# Addendum 6

Sugarcreek Water Treatment Plant and Wellfield Improvements

**Addendum No. 6**  
**June 3, 2022**

FLUORIDE BUILDING  
PROCESS  
SCHEMATIC

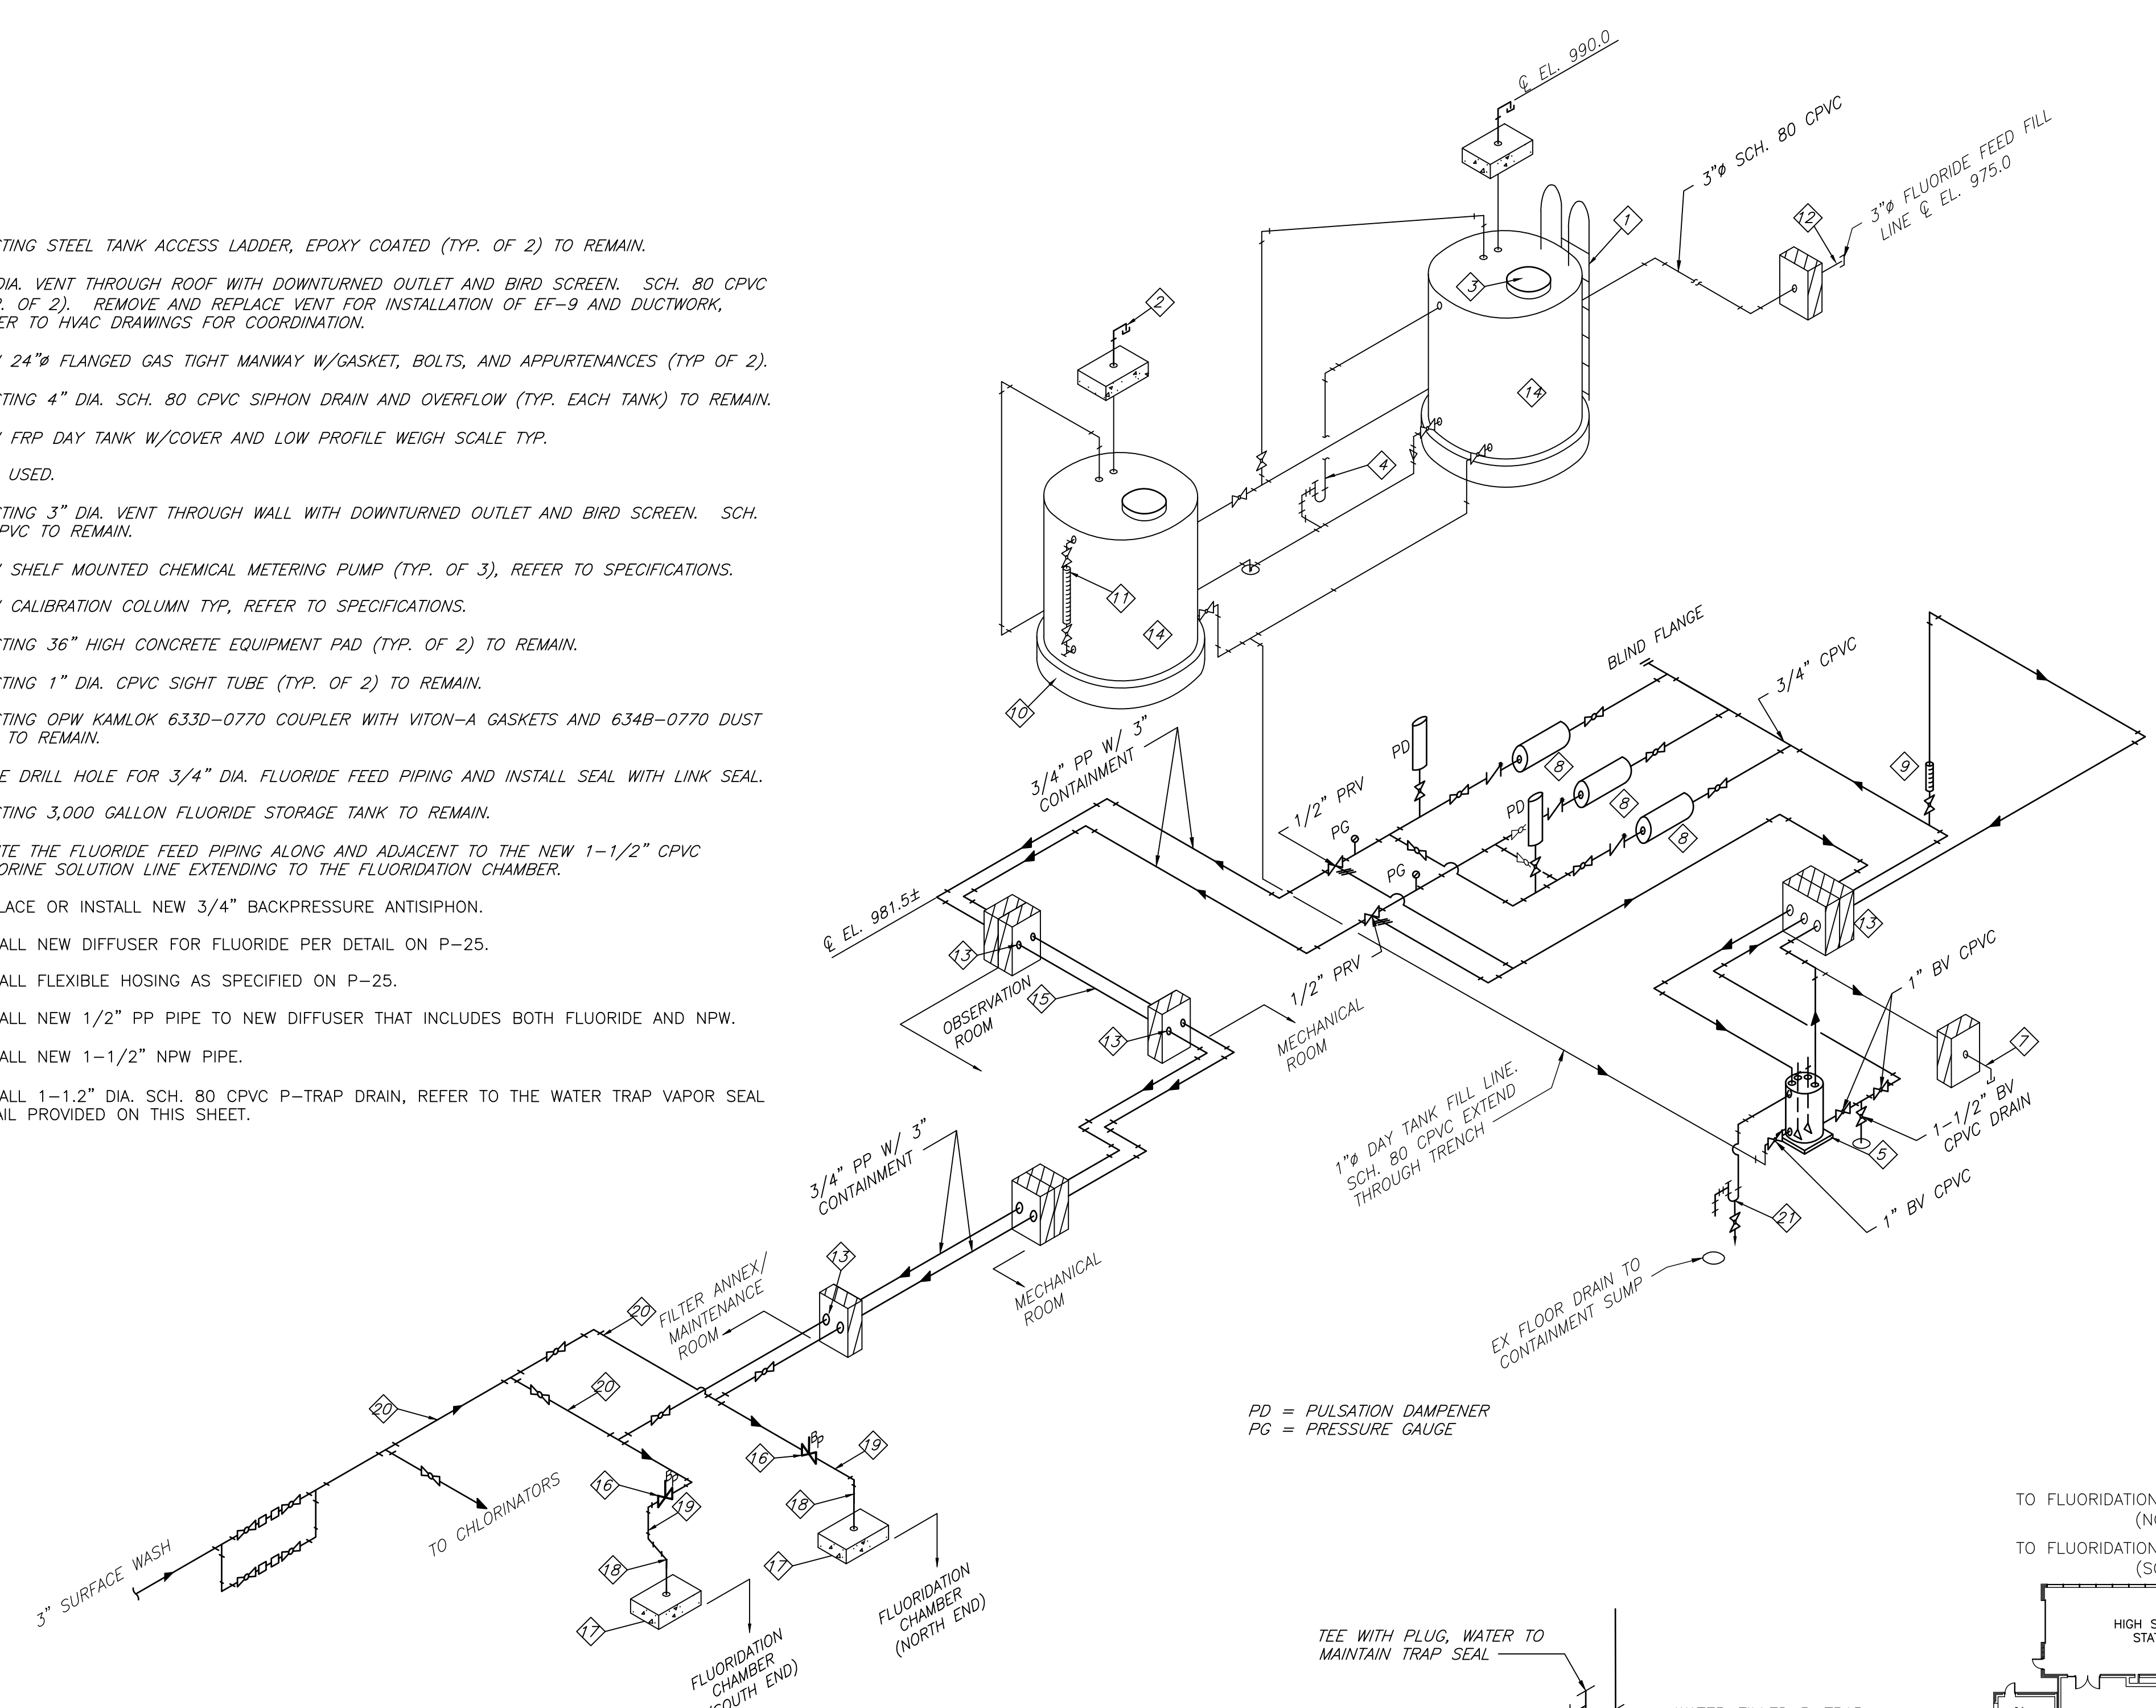
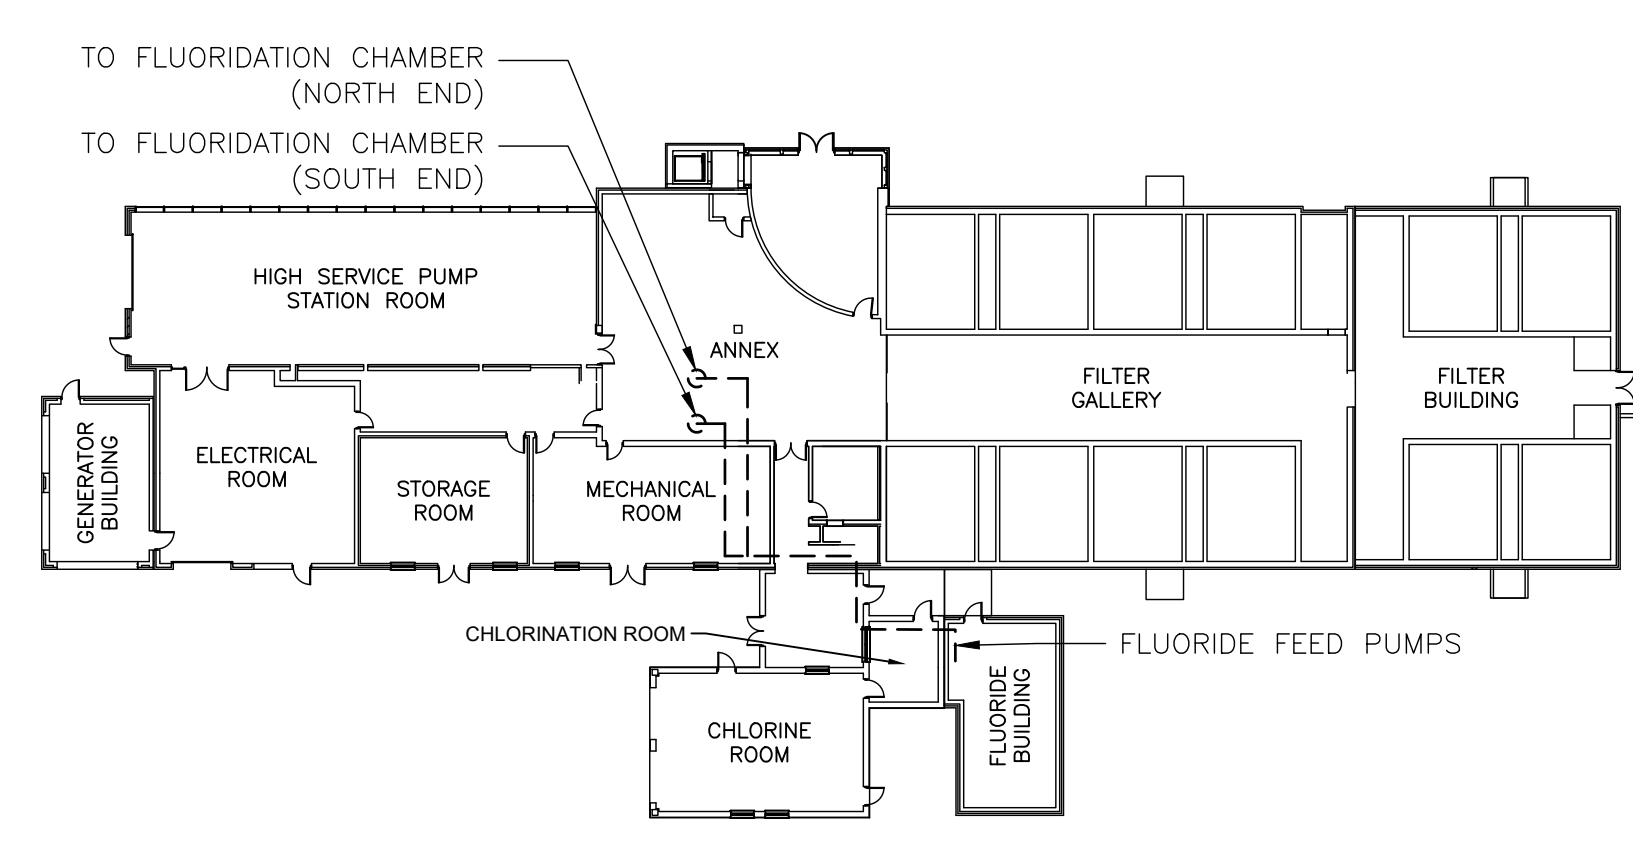
29. **Sheet P-36, Fluoride Building Process Schematic.** REPLACE with the attached P-36. Revisions were made for piping materials and added notes.
30. **Sheet A-2, West Aerator Building Architectural Elevations. For General Note 2, ADD “Window type W-9”.** For General Note 2, ADD “Window type W-9”.

MAIN BUILDING ARCHITECTURAL ELEVATOR WALL SECTION

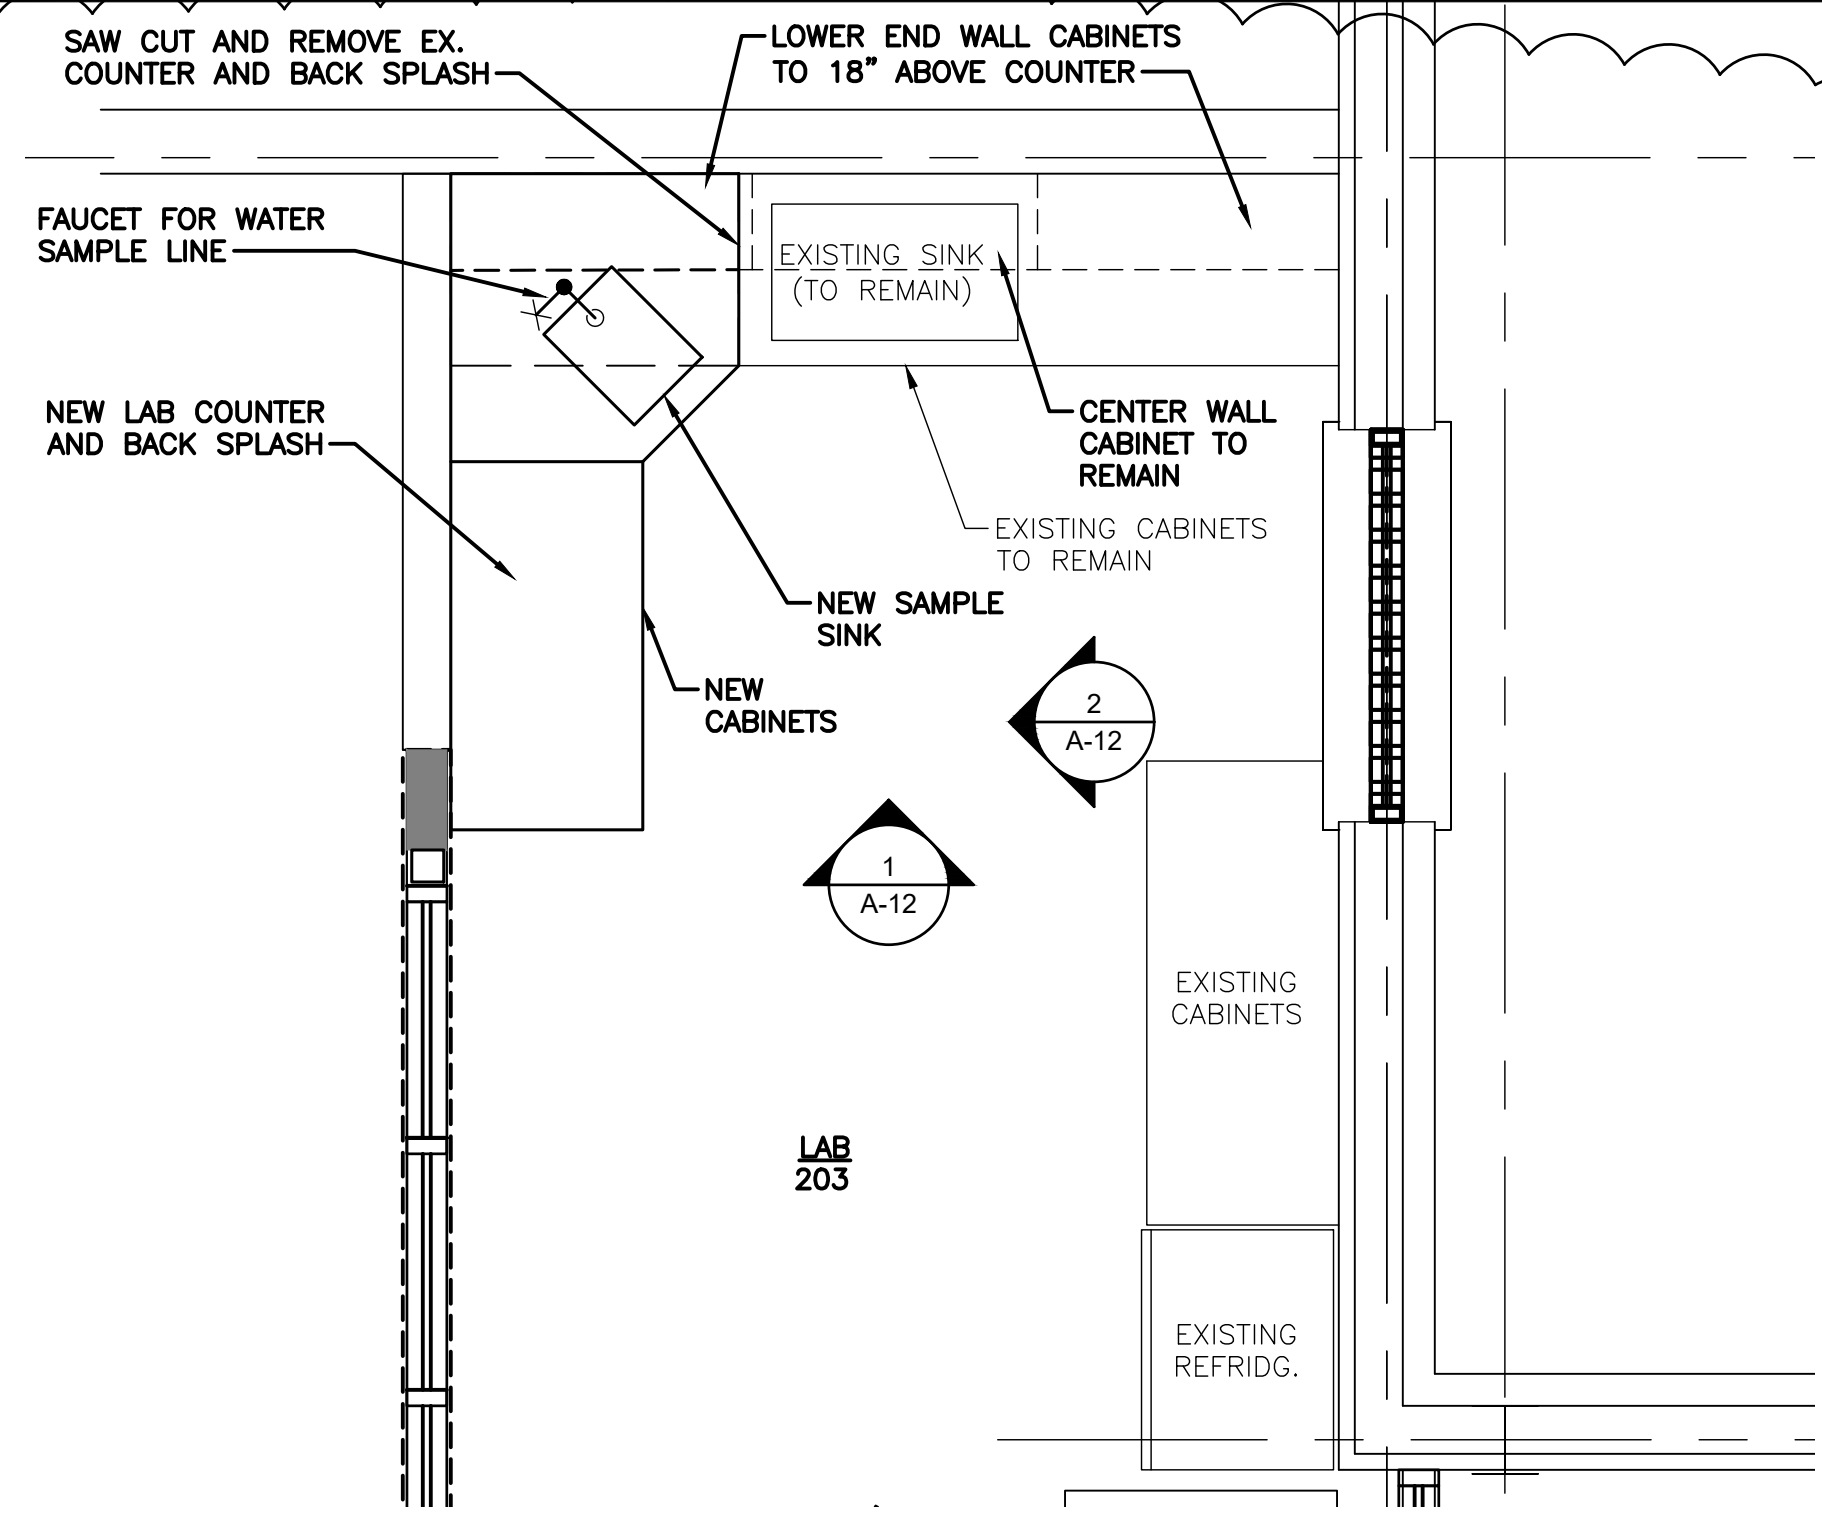
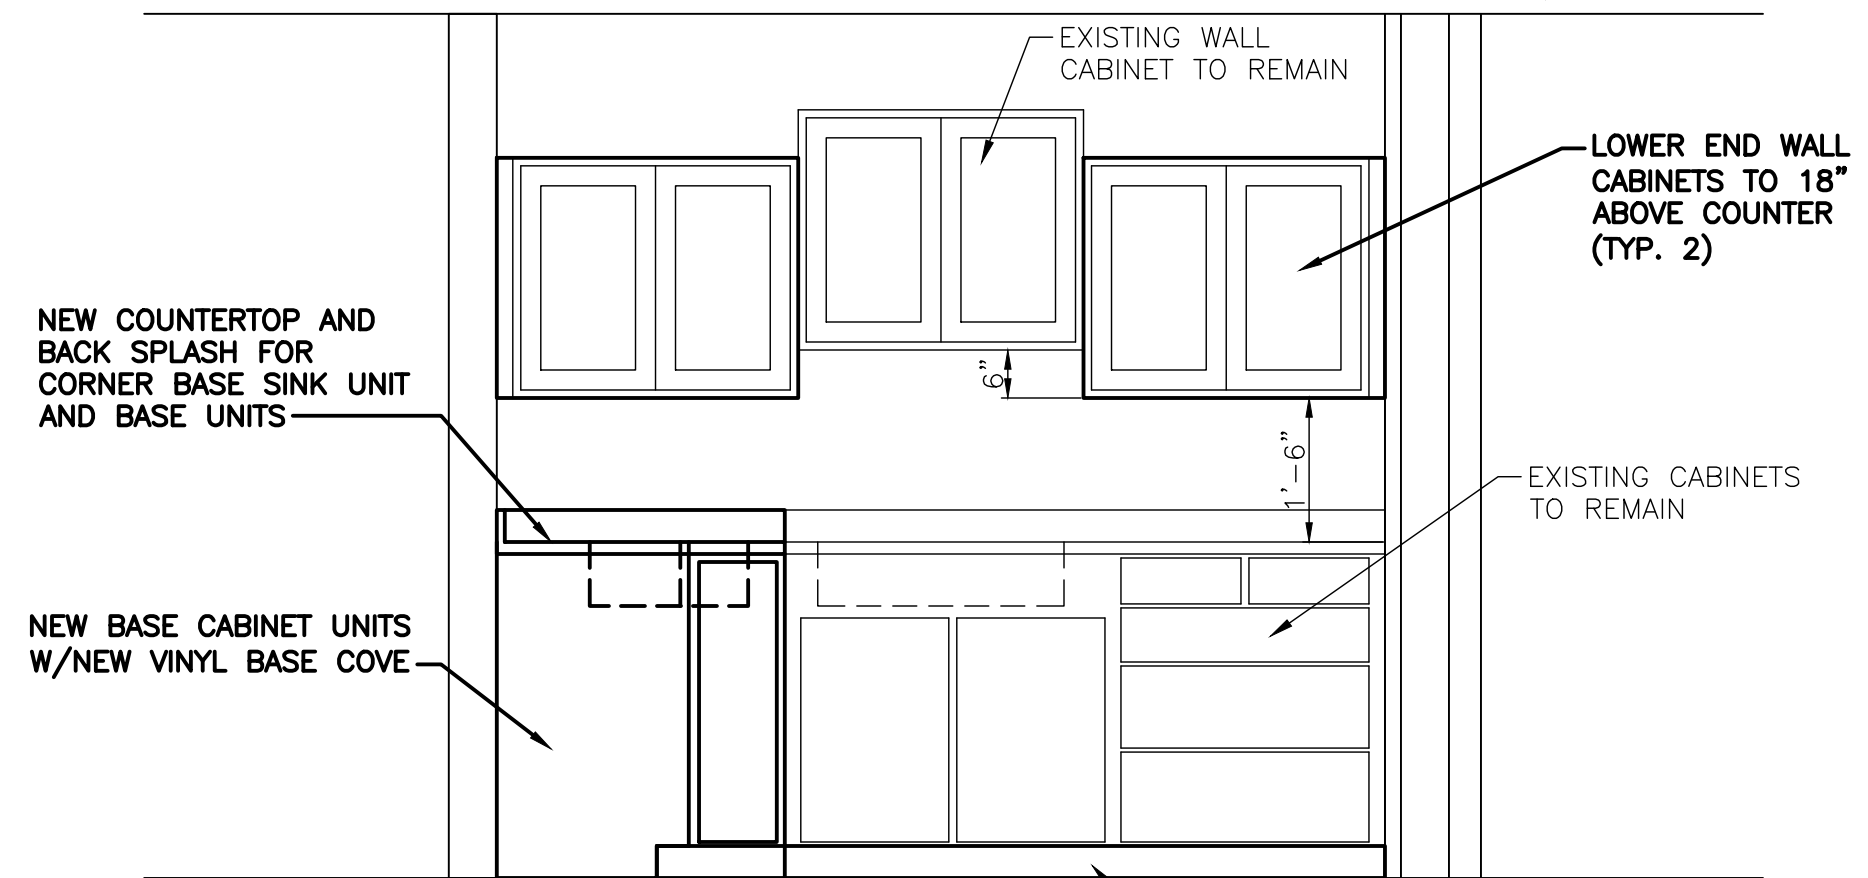
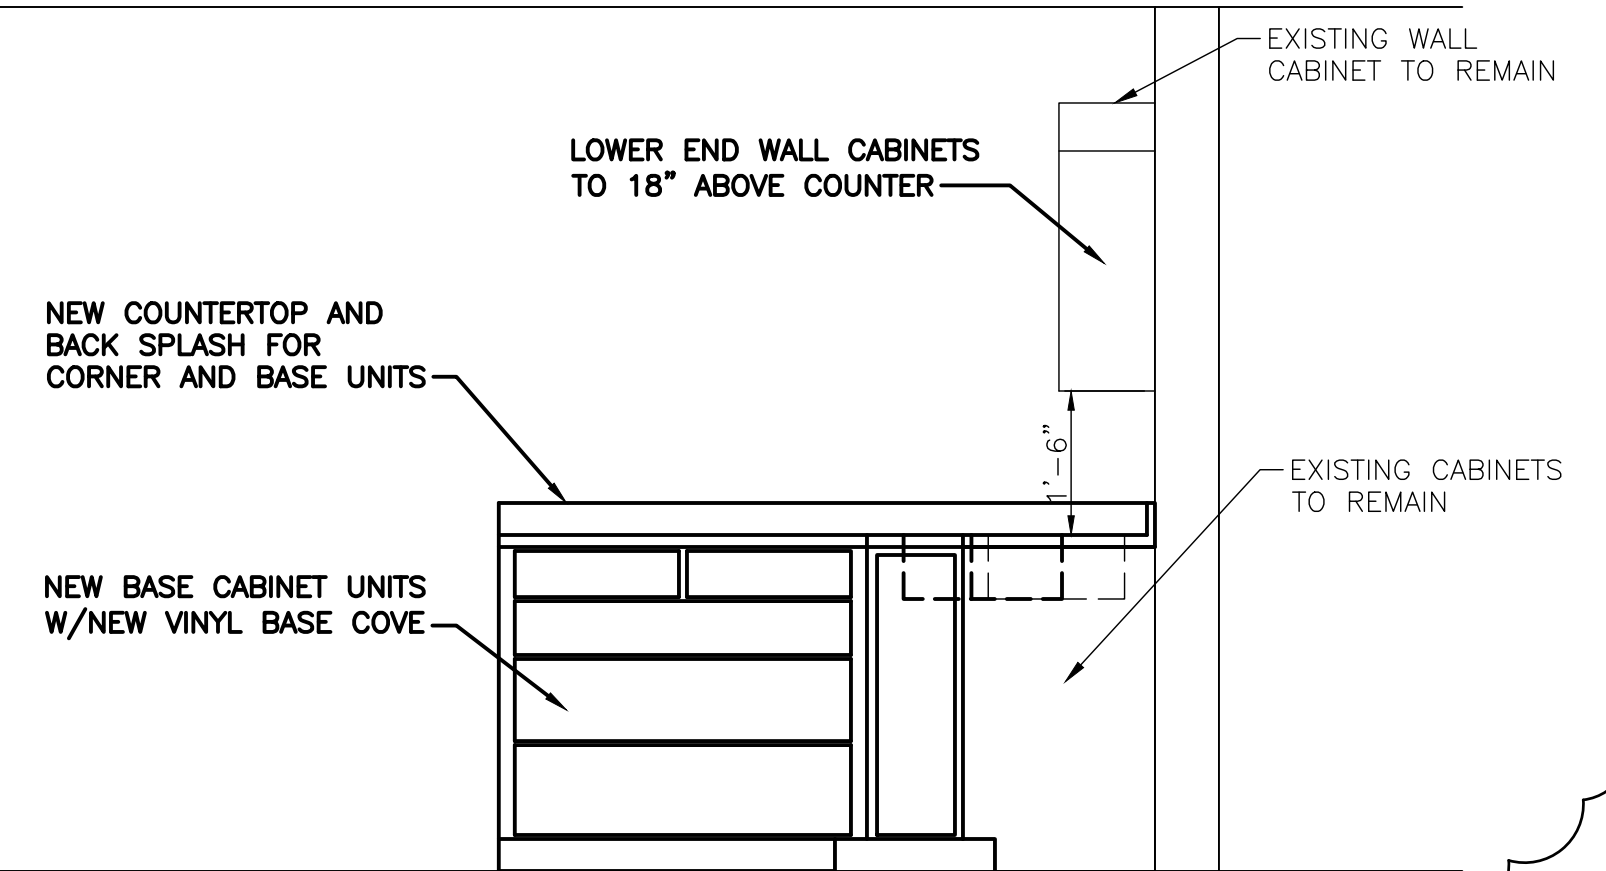
- ADD New Work Coded Note 12, “12. Clean and buff finish existing aluminum handrail and spindles.”
36. **Sheet A-12, Main Building Architectural Elevator Wall Section.** ADD attached Sketch A-12. Provides elevation of new casework in Laboratory Room 203.
